| Project | IEEE 802.16 Broadband Wireless Access Working Group < http://ieee802.org/16 > | |
| Title | Solution upon the AIs in 46 meeting. | |
| Re: | 80216h-06_028 : Title: TGh Report closing plenary- Meeting 46 (2006-11-17) | |
| Abstract | Feedback on the AI summarization C80216h-06_123.xls | |

Change figure h12 as indicate:

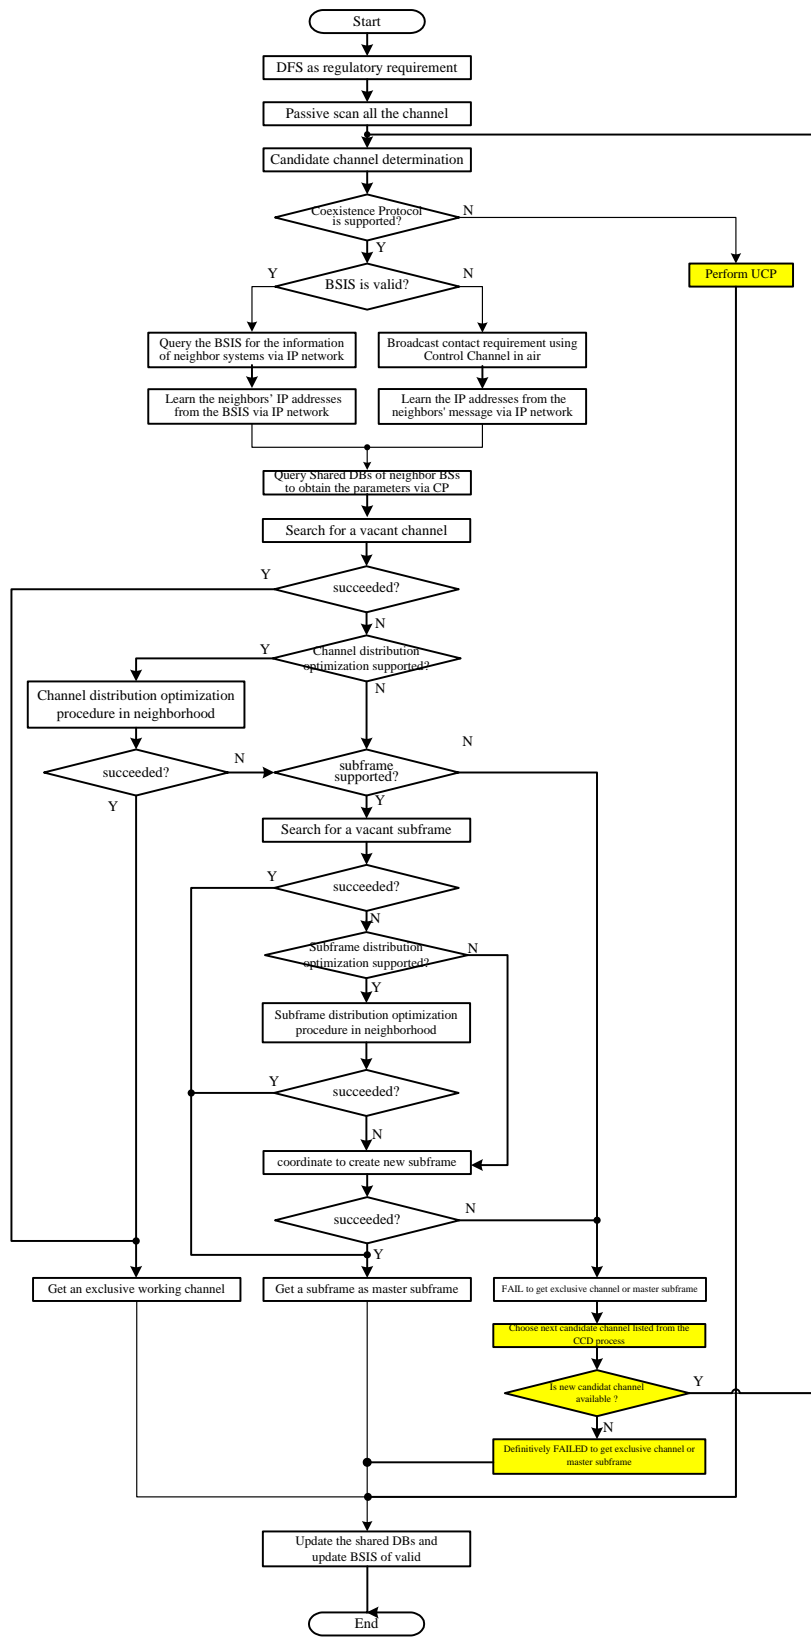
| AI | comment | Situation | By | Concern |
|--|---------|--------------------------|--------|--|
| | 222 | confirmed | David | "Perform UCP" should be enough, (Paul have some other concern on the whole flowchart.) |

Comment 222 resolutions, by David (not having consensus yet):
